Date: 13th April 2021

Your ref: 15/00314/AOP

Re: South West Milton Keynes, Updated Transport Assessment

Location: Land South Of The A421 West Of Far Bletchley North Of The East West Rail Link And East Of Whaddon Road Newton Longville

Junction 1: Sherwood Drive/Water Eaton Road/B4034 Buckingham Road – Mitigation Proposal

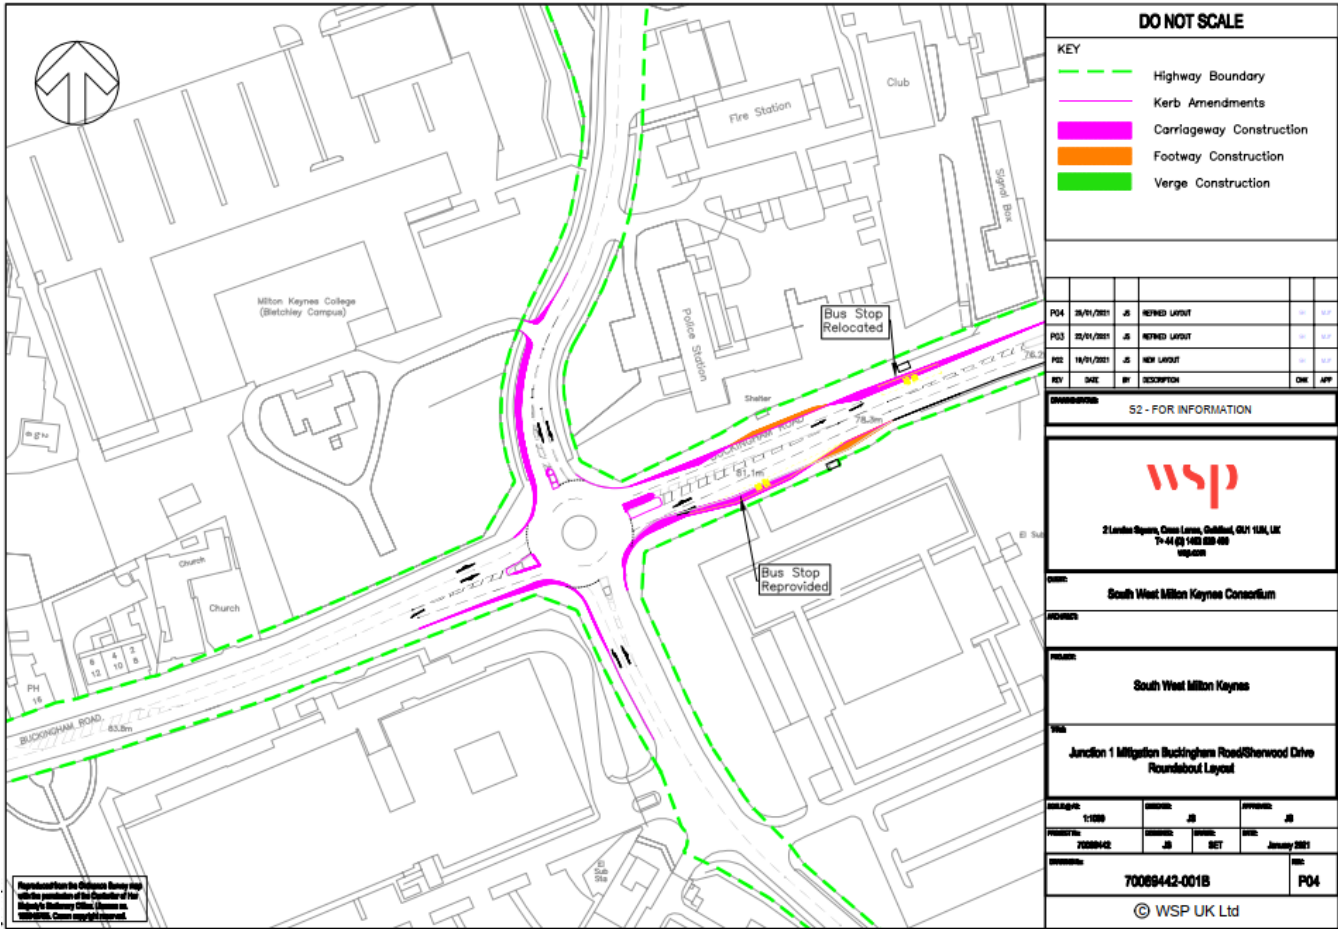
The predicted decrease in capacity due to development traffic would be considered significant and the Applicant has submitted a mitigation scheme. This includes providing two straight ahead lanes on the Buckingham Road (B4034) arms of the junction and minor kerb amendments to the Water Eaton Road and Sherwood Drive arms. To allow for two lane exit on the Buckingham Road (East) the bus stop layby on the north side of road has been replaced with an on-carriageway stop.

The results show that with the provision of the proposed mitigation queueing and delay on B4034 Buckingham Road (W) is significantly reduced when compared to the existing layout 2033 Do Nothing scenario in the AM and PM peaks with delay now less than 20 seconds (compared to 6 to 7.5 minutes). Buckingham Road (E) would see a slight increase in queues in the AM, but now distributed more evenly across the lanes with no blocking back to the previous roundabout, whilst in the PM the new layout would see a reduction on queue and delay that would still block to the next roundabout but not beyond and is an improvement compared to the DN scenario. There would be slight worsening of results for Sherwood Drive in both peaks, and Water Eaton Road in the PM but overall the junction results would see an improvement considering both peaks compared to 2033 DN with the demand weighted Junction Delay reducing from 250.19 to 84.96 seconds in the AM and from 242.62 to 89.36 seconds in the PM.

Buckinghamshire Council raised concern over the apparent new footway width on Buckingham Road (E) on the southern side is narrowed to accommodate the revised bus stop location. A site visit was performed to measure existing footway widths on the southern side of the road either side of the junction, some discrepancy was noted between the OS plan used as basis for design and the current layout, with variations between 0.4 and 1.8 metres. This may result in the footway behind the bus stop being in the region of 1.5 metres. This concern was provided as part of ongoing application discussions and the Applicant responded by formal letter dated 7th April 2021, this resolved that a width of 1.5 metres would be compliant with the Department for Transport's Inclusive Mobility¹ as the minimum acceptable footway width to enable a wheelchair user and a walker to pass one another. The Applicant also stated that further assessment would be completed at the detailed design stage and subject to finalising the s278 agreement. Whilst the actual resultant footway width will not be known until detailed design is performed the potential conflict point is noted for future consideration.

Junction 2: Shenley Road/Newton Road/B4034 Buckingham Road – Mitigation Proposal

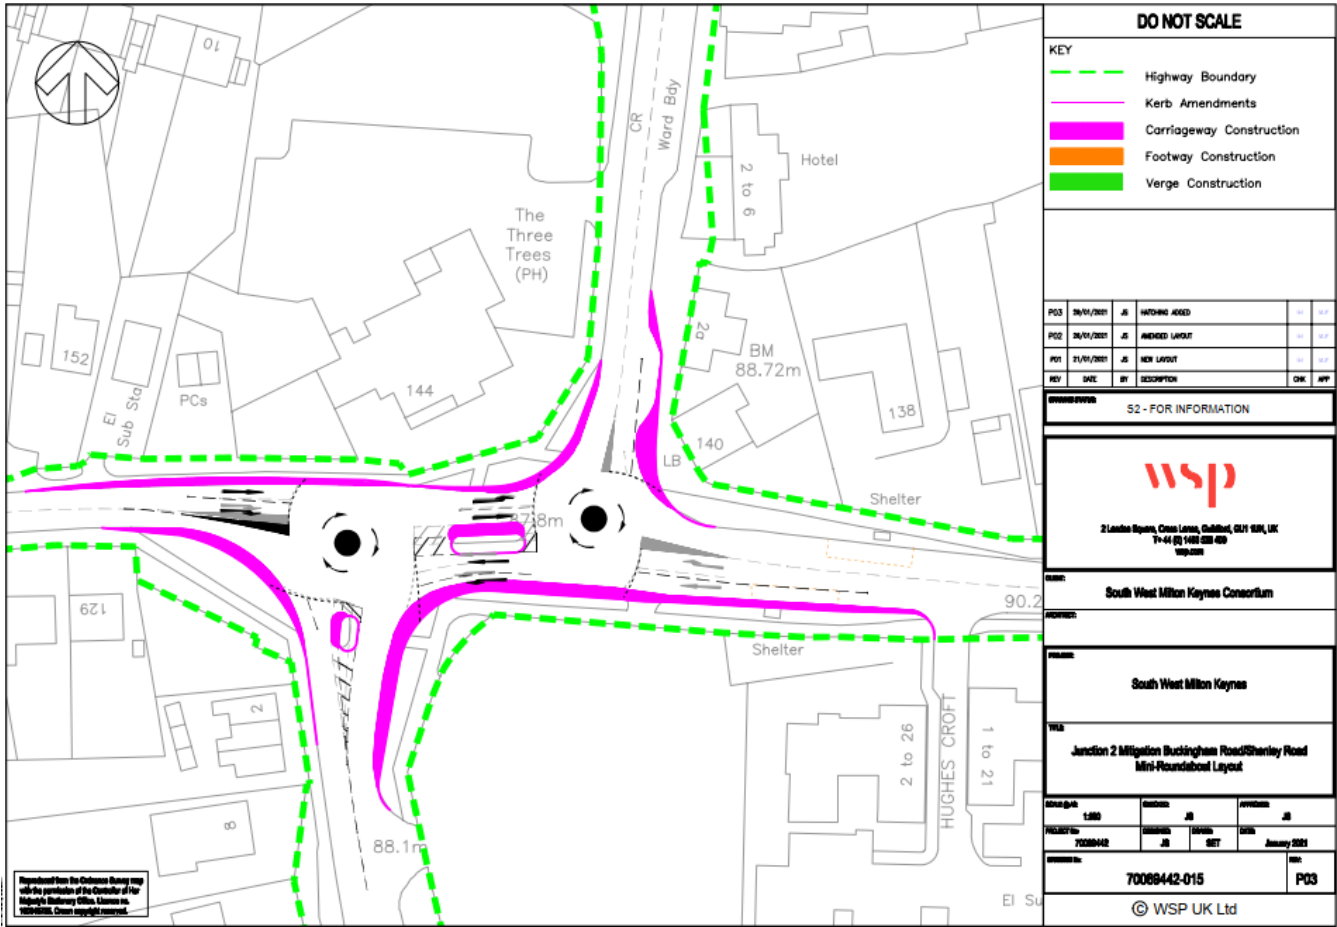
The predicted decrease in capacity due to development traffic would be considered significant and the Applicant has submitted a mitigation scheme. This includes kerb widening on all arms of the mini roundabout to improve capacity. To allow for two lane entry on Shenley Road the existing short layby (covered by no waiting at any time restrictions and hence not used for parking) would need to be removed.

The results show that with the provision of the proposed mitigation that overall the junction results would see an improvement considering both peaks compared to existing layout 2033 DN with the demand weighted Junction Delay reducing. At the eastern junction Buckingham Road (E) in the PM queue will still extend to Wilkinson Close (approximately 750m), this is impacted by the downstream internal link storage being filled, creating an exit restriction. The remaining arms on the eastern roundabout would have improved or similar results compared to 2033 DN. At the western junction in the AM queues and delay are reduced compared to 2033 DN existing layout with Buckingham Road (W) seeing queue reductions from 60 to 33 and delay reducing from 7 to 2.5 mins. Newton Road is also expected to see an improvement, with queues and delay reducing by over half compared to DN 2033, however, a new lane has been formed but with the turning proportions unbalanced in both peak periods the outside lane is likely to suffer from some starvation so the benefits on this arm are likely to be overestimated, although overall it is considered that the junctions will see improvement.

Junction 5: Tattenhoe Roundabout – Mitigation Proposal

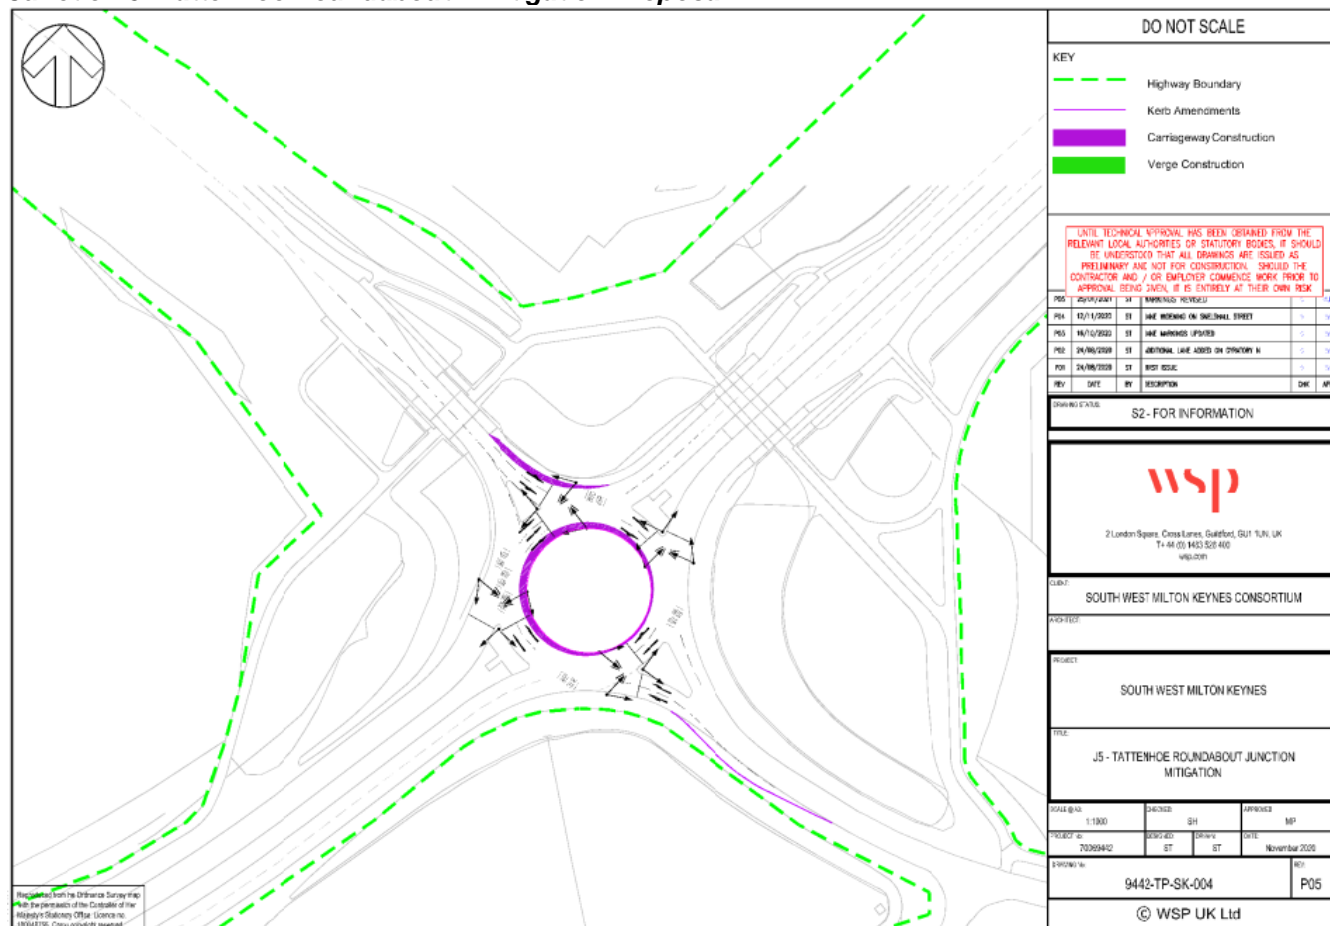
The predicted decrease in capacity due to development traffic would be considered significant and the Applicant has submitted a mitigation scheme. This includes altering the junction to 'part-time' traffic signals that would operate at peak periods with flare extended on Buckingham Road to provide greater stacking space. The central island would also be slightly narrowed to better accommodate two-lane straight-ahead and turning movements.

The results show that with change to part-time signal control shows, that all arms would see an improvement considering both peaks compared to 2033 DN existing layout, especially on Buckingham Road where queues would reduce from 50 to 8 in the AM and 59 to 20 in the PM, which would be contained in the link between the junction and the new access on Buckingham Road. Snelshall Street would still experience queues and delay but these would be less than those predicted for the 2033 DN scenario and would not extend back to J12.

Junction 6: Bottledump Roundabout – Mitigation Proposal

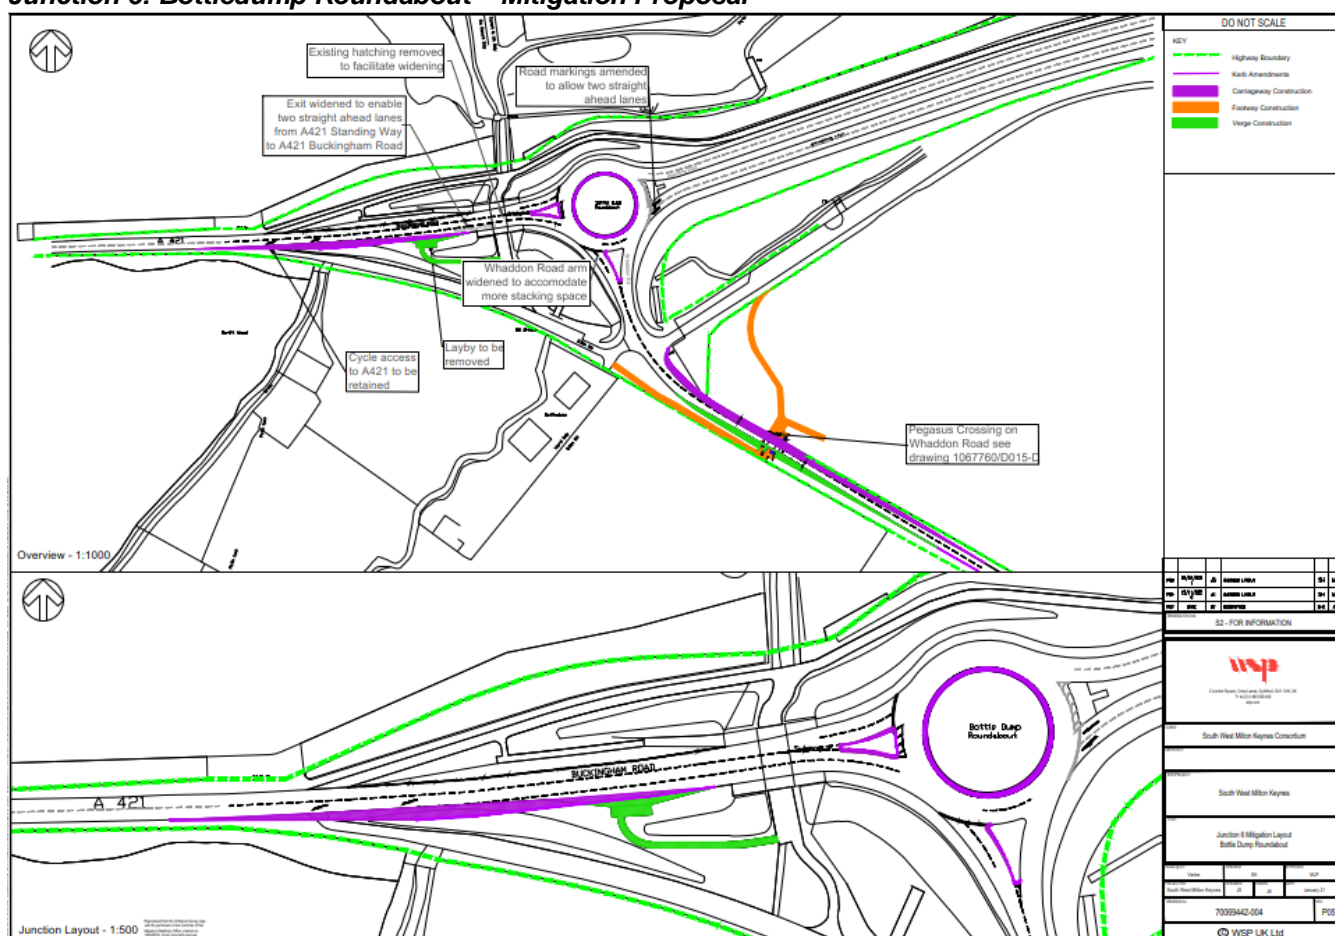
The predicted decrease in capacity due to development traffic would be considered significant for the A421 Standing Way and Whaddon Road and the Applicant has submitted a mitigation scheme. This includes widening the Buckingham Road exit to two lanes for an extended length to allow straight ahead movements from both lanes on A421 Standing Way, this would require a reduction of the flare available on A421 Buckingham Road. Furthermore, Whaddon Road would be widened slightly and the central island narrowed to better accommodate two lane straight ahead movement. A new Pegasus crossing is also proposed on Whaddon Road south of the junction.

The results show that with the provision of the proposed mitigation A421 Standing Way would no longer suffer from lane starvation and would be well below existing layout 2033 DN queues and delay results and operates well within capacity. With the addition of the extended two lane exit and relocation of the exit restriction Whaddon Road also now operates well within capacity with negligible queues and delay. However, there is a minor increase in queuing and delay on the Buckingham Road arm results. Queuing on Buckingham Road increases from 11 vehicles in the 2033 DN scenario to 28 in DS1, an increase of 17 vehicles. Delay increases from 22 seconds to 49 seconds, an increase of 27 seconds.

Junction 12: Kingsmead Roundabout – Mitigation Proposal

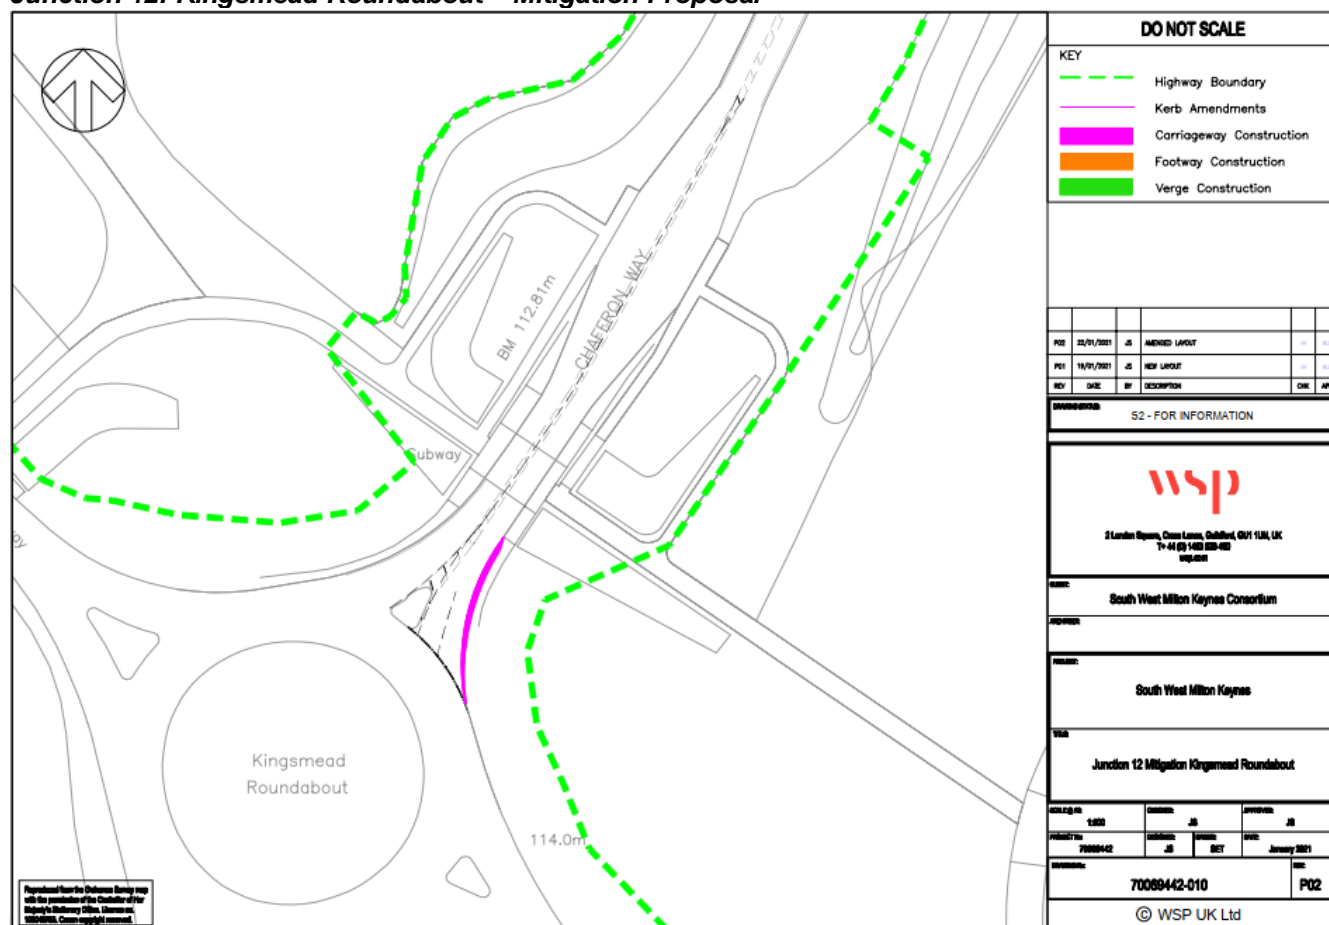
The predicted decrease in capacity due to development traffic would be considered significant for Chaffron Way and the Applicant has submitted a mitigation scheme. This includes kerb widening Chaffron Way to improve capacity.

The results show that with the provision of the proposed mitigation means that overall the junction results would see an improvement considering both peaks compared to the 2033 DN existing layout with the demand weighted Junction Delay reducing in the AM from 113.41 to 101.68 seconds and in the PM from 185.82 to 155.87 seconds. Chaffron Way still operates above theoretical capacity (RFC of 1.0) but has improved compared to the DN scenario with delay reduced from 7.5 to 6.5 minutes in the AM and 9.5 to 8.3 minutes in the PM, with the queue in the PM no longer blocking back to Junction 13. Minor increases in queuing and delay are evident on the other arms of the junction but overall, the mitigation measures would provide an improvement when compared to the 2033 Do Nothing scenario.

Junction 14: Furzton Roundabout – Mitigation Proposal

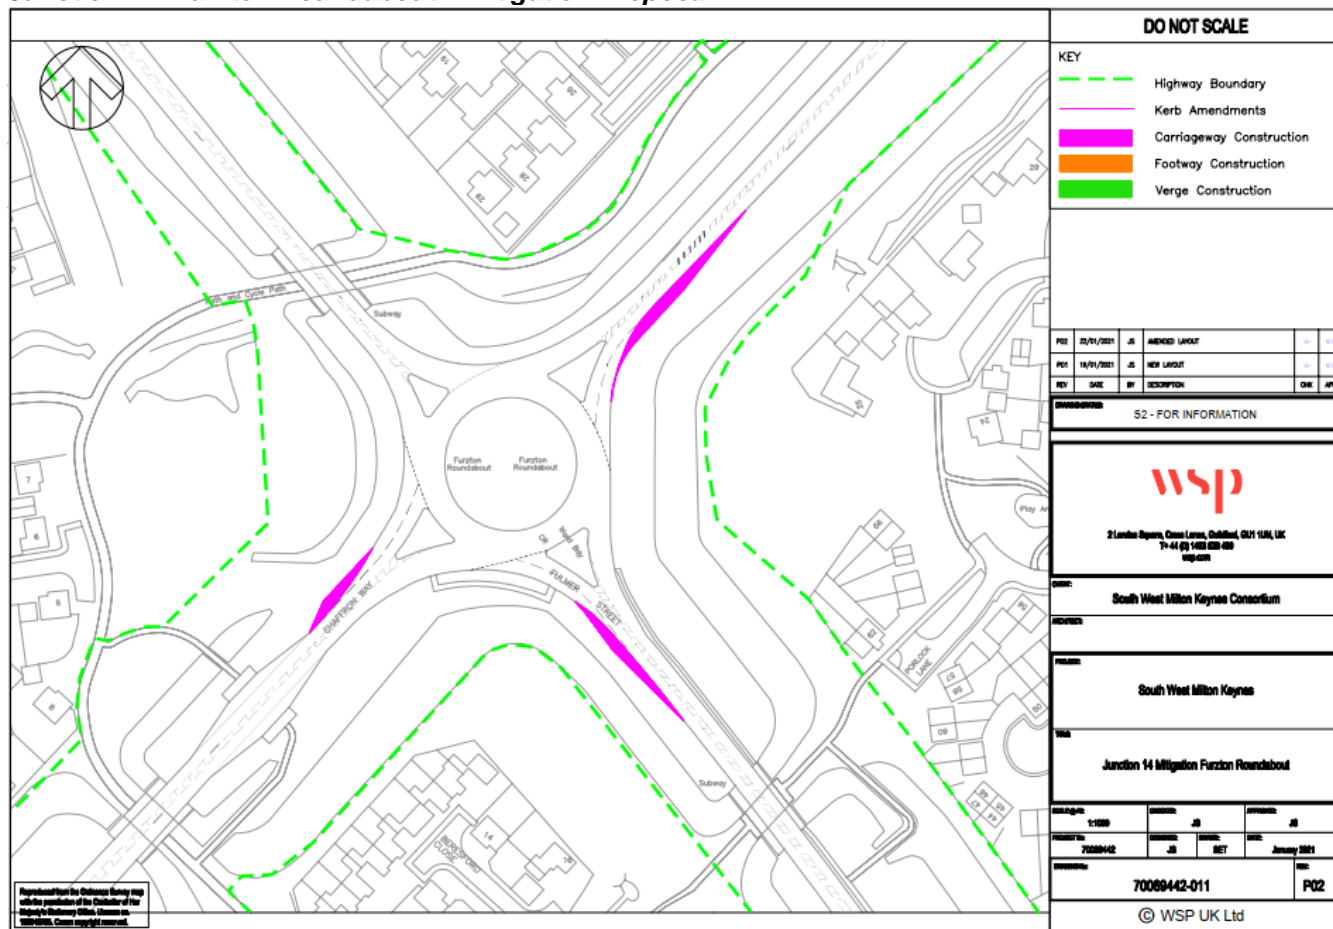
With the addition of the development traffic (DS1) those already poorly performing arms would see further increases in queueing and delay, with the largest increase evident on Fulmer Street (S) in the AM peak and Chaffron Way (E) in the PM peak. The predicted decrease in capacity due to development traffic would be considered significant and the Applicant has submitted a mitigation scheme. This includes kerb widening on Chaffron Way (E) and (W) and Fulmer Street (S) to improve capacity.

The results show that with the provision of the proposed mitigation that overall the junction results would see an improvement considering both peaks compared to 2033 DN with the demand weighted Junction Delay reducing in the AM from 364.45 to 193.91 seconds and in the PM from 389.62 to 143.39 seconds. When comparing DS1 to 2033 DN existing layout both Fulmer Street (S) and Chaffron Way (W) in the AM still operate at or above theoretical capacity (RFC of 1.0) but queues and delay are less with Chaffron Way (W) now no longer blocking back to J13 (Westcroft Roundabout). While in the PM Chaffron Way (E) is also still above theoretical capacity (RFC of 1.0) but queues and delay are less and will no longer block back to The Bowl roundabout.

Junction 17: Emerson Park Roundabout – Further Mitigation Proposal

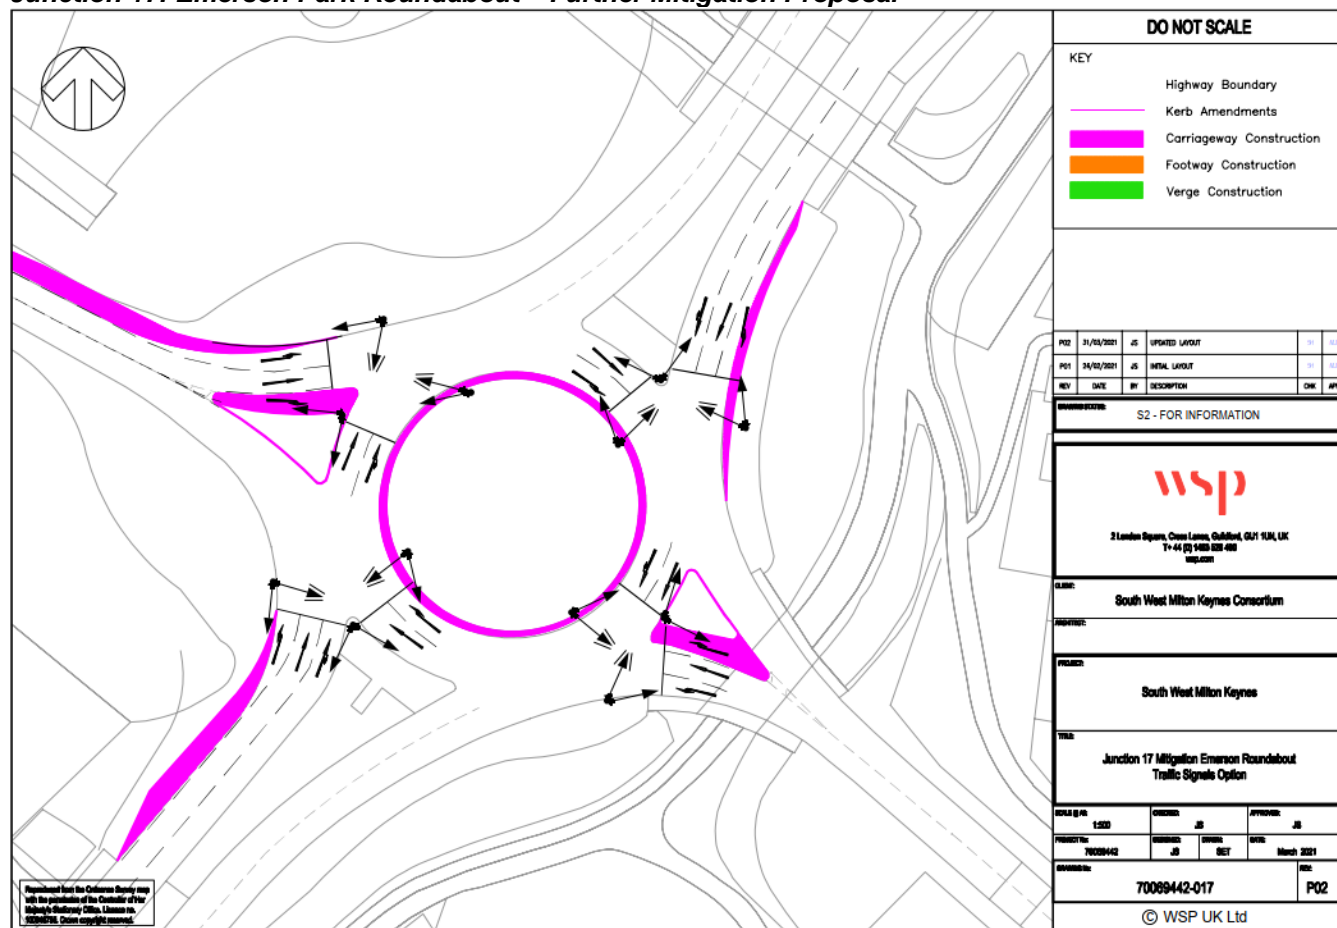
BC highways raised concern over the predicted negative impact on demand weighted Junction Delay in the PM and the resultant long queues on A421 Standing Way (N). The Appellant provided a response in a letter dated 7th April 2021. This provided details of a potential further mitigation measures that could be deployed at the junction, this involved conversion of the junction to part-time signal control.
